527 Old Lancaster Road, Haverford Station Historic District

25-09

# Preliminary Consultant Review

1017 Black Rock Road, Gladwyne Historic District

New Residence: Proposed Site Plan

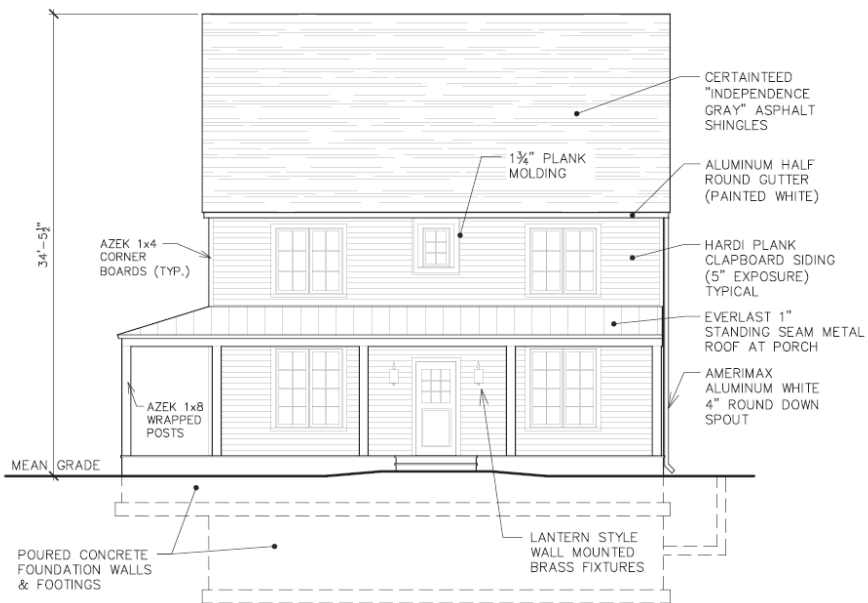
- As discussed at the HARB meeting, the site plan should be edited and resubmitted to the HARB showing the planned location for outdoor mechanical units. It was stated during the meeting that the units would be placed at the back (side or rear) of the garage. (This is being submitted.)

New Residence: Proposed Front Elevation

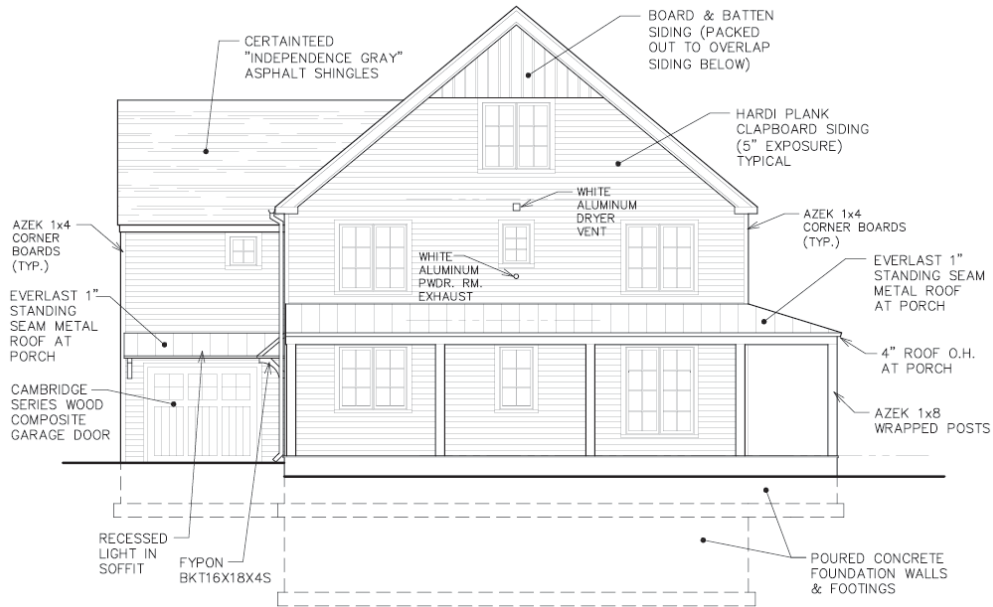
- A single tread off the front porch has been added to the front elevation drawing in the updated submission. Applicant should edit the drawings to show the step at the first floor plan and should note the material of the tread and any planned details flanking the step.

- HARB requested the typically required details and notes for the project. Applicant has included within its updated submission a typical wall section, porch eave and post detail, and house eave detail. These are helpful details but should be coupled with annotation on the elevations that is in agreement with the details. Plans and elevations have been edited to include indication of the proposed pent eaves over the rear door and garage door, corrected location of doors and windows on the right façade, and inclusion of the step at the front porch. Additional annotation, through a list of key notes or materials or standard annotation should be added to at least the front and right side façade so that it is clear where the materials indicated in the wall section and other section details apply. Specifically, elevations

should include annotation that notes the following: roofing material at all roof locations, gutters and downspouts, vent locations and materials, wall finish at all wall locations, trim material at all different trim type locations (eave, rake, window trim, door trim, porch fascia, rake, post), foundation material, etc so that all materials are identified not just their form (siding) but their specific material (cementitious? PVC? Poly ash? Fly ash? Wood?)

Proposed Turn-Around Area

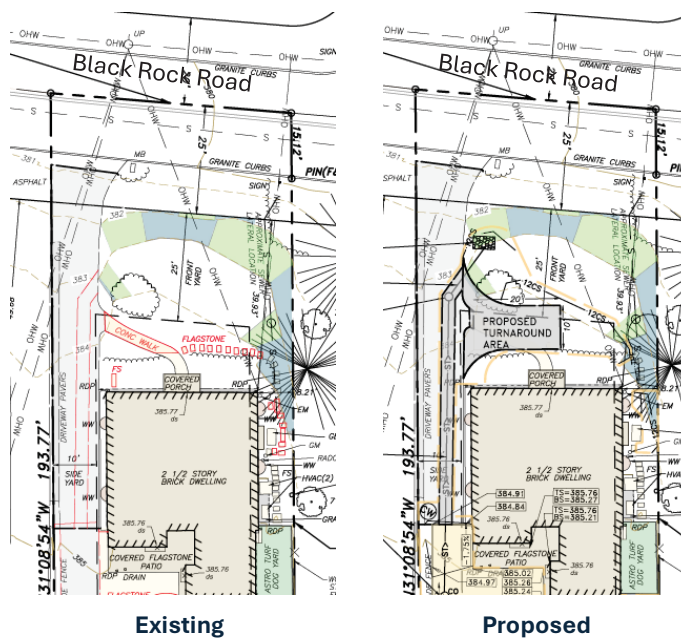
- Ideally, a paved area providing a turning radius could be provided at the back of the lot, in front of an adjacent to the garage. If for some reason that is not possible and the front yard turning radius is necessary, it should be limited to the minimal area required, and screened with vegetative plantings to obscure the paving area. Some of the vegetative screening indicated within the landscaping plan may be more successful in its goal of screening if planted just in front of the paving rather than at the street.

Overall View From Lancaster Ave.

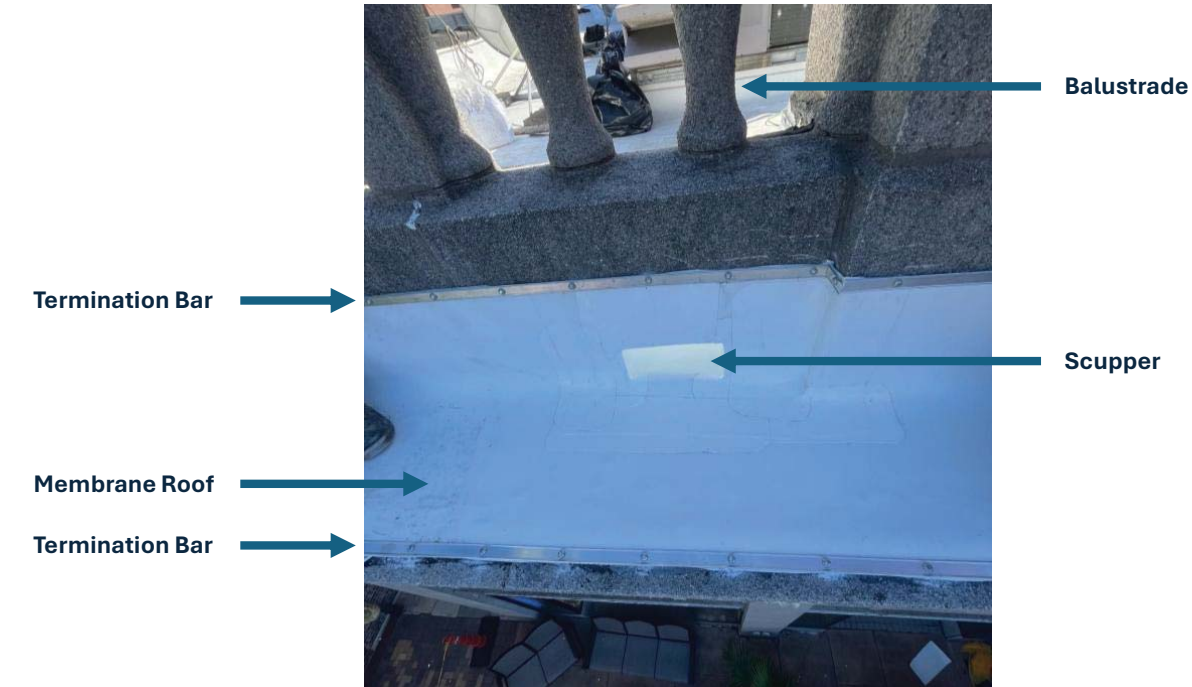
- As installed, the white membrane flashing extended above (by 8 or 12”) the line of the original flashing in that area, and given its extent and color is highly visible from the street and in great contrast to the concrete and stone-colored assembly of the building and the other materials of the district. The original flashing, which was at a height that was just barely visible from the street, was a sheet metal – most likely copper – which had been coated over with an asphaltic coating to seal open joints over the decades. The dark line of the top of the coating can be seen from street views of the building.

- The appropriate treatment at such a condition, when roofing and flashing systems are being replaced, would be to replace the original flashing with new sound material, matching the material, dimensions and profiles of the existing assembly. The applicant has agreed to remove the recently installed flashing and provide new copper flashing that will be let into the existing reglet at the base of the balustrade assembly.

- The existing non-permitting membrane flashing at the east wing and the membrane flashing around the scuppers at the west wing will be removed.
- Where the termination bar will be removed, all fastener locations will be patched.
- Any pre-existing flashings and coatings will be removed, with the original reglet to be cleaned to allow for the installation of new lead-coated copper or Freedom Gray counter-flashing and sealant.
- The applicant has agreed to install a flashing strip on top of the new termination bar that will not be visible to the public.
- The applicant will provide section detail drawings showing the location and dimensions of any existing materials to remain, new flashing that is to be installed, and the scupper, for subcommittee review.
